Commercial processing checklist

Address:	362 Matakana Valley Road Matakana 0985			Consent N°:	BCO10364430		
Processed by:	Ik Sun Yang			Date:	30 Mar 2023		
Description:	DBC – Replacement market sheds and 10 workshops including toilet facilities <i>Two new market sheds for retail and workshop purpose. Shed 1 - 8 x retail/workshops and toilet facilities. Shed 2 - 2 x retail/workshops. On-site wastewater system, stormwater control devices and associated site works.</i> RFI 2 - revise the DOW <i>05/05/2023 Accepted – the applicant confirmed that the building is to be owned and operated by the sole owner.</i>						
Exposure Zone	C			Wind zone	H		
Building complexity	Com 1			Processors competency	Dev Com 1		
	Level confirmed?		Yes		Competency confirmed?	Yes	
	If the answer is No, you must update the complexity in the system and record your reasons on the checklist below						
Number of levels above / below GL		1		Type of application	Building

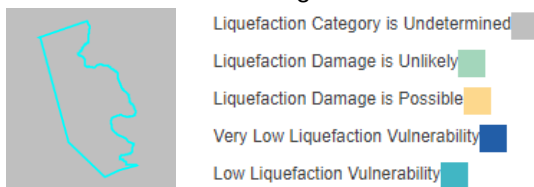
7. Please indicate finished ground levels on site plan (sheet 101) – the spots of FGL should be around the proposed buildings, carparks, driveways, effluent field area ...ect. You may provide an enlarged part site plan for clear siting datum information.

05/05/2023 Accepted – FGL indicated on additional enlarged site plan (sheet 01.1)

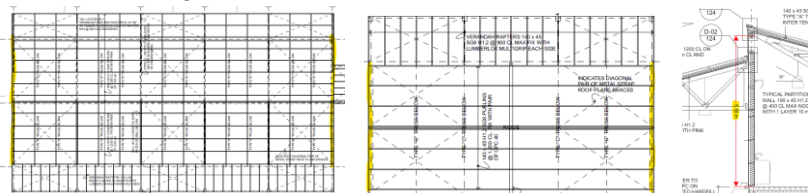
9. Please confirm any specific engineer's design is required for the pipe penetration to the footings.

05/05/2023 Accepted – additional service penetration requirement note added on revised plans

(sheet 107, 112, 117 and 122) as confirmed by engineer.

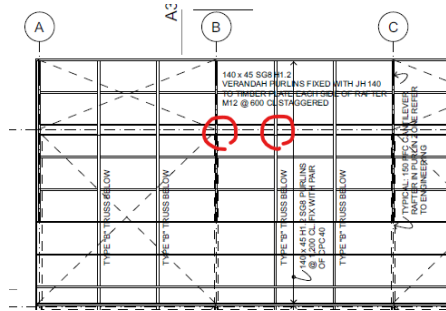
13. Please provide types, sizes and fixings of the lintels for the doors and windows openings on plans to show compliance to NZBC B1.

05/05/2023 Accepted – lintel size and fixing type provided on revised sheet 108 and 118 in accordance with table 8.9 of NZS3604:2011 or as per engineer's requirement (engineering calculations provided) and lintel fixing installation added on sheet 135 as per Studlok

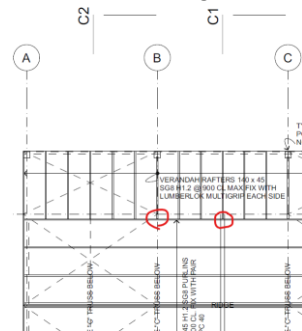
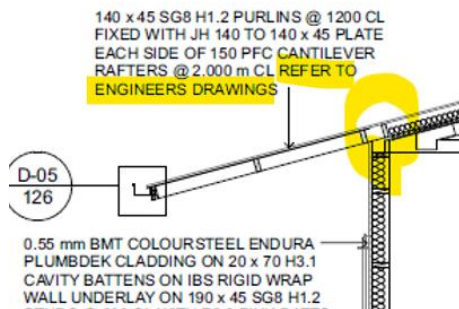
15. Please provide/clarify the cantilevered roof framing members and connection to trusses or rafters on plan to show compliance to NZBC B1.

- For shed 1 - provide project-specific connection/fixing details as the roof framing connections on grid A, B, C, D, E and F, and the connections between grids could be

different,

05/05/2023 Accepted – detail D5 on sheet S205 checked ok. And agent confirmed that the 150 PFC to be placed on top of trusses @2M to all the cantilevered roof – this has been indicated/revised on sheet 109

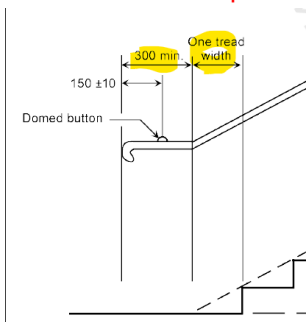
28. Please demonstrate/clarify how paragraph 4.1.7 (Visible/contrasting nosing on stair treads) to be achieved.

05/05/2023 Accepted – Ecoglo F15-175 noising provided – refer emergency lighting plan provided by Ecoglo

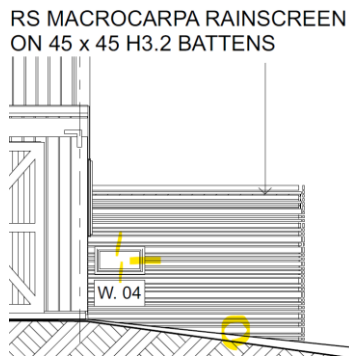
39. Please provide note for the roof plan of shed 2 and specify the size and type of gutter, roof type and falls...etc. No note provided on sheet 121.

05/05/2023 Accepted – notes for roofing added on revised sheet 121

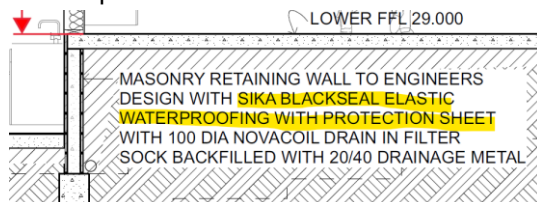
44. Please provide window head, jamb and sill details for Macrocarpa rainscreen with Hardi-flex cladding on plan to show compliance to NZBC E2.

05/05/2023 Accepted – window head, jamb and sill details for Hardi-flex cladding provided on sheet 28.2

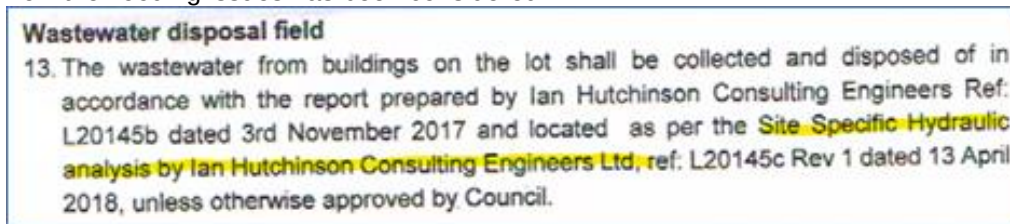
8. Please confirm/update the Total Daily Wastewater production. Note that, this should be for everything on the site, not just the two new buildings. This item was also requested by our specialist previously.

- Given that more than one on-site wastewater treatment and land disposal system is proposed on the site, the proposed wastewater discharge from Shed 1 and Shed 2 must be assessed against permitted activity standard E5.6.2.4 of the AUP. Provide an assessment of the proposed wastewater discharge against permitted activity standard E5.6.2.4. What is the site area to combined wastewater discharge volume ratio? The 2017 wastewater system design report only considers flow from Shed 1 and Shed 2 (the total volume of wastewater discharged on-site needs to be considered). If 100% reserve area is available per wastewater system show this on the site plan.

03/08/2023 Accepted – revised TP58 Appendix E form provided checked ok, all sections completed in full provided in line with the proposal of this BC application. Total daily production calculated/specified include new (931L) and existing(680L)
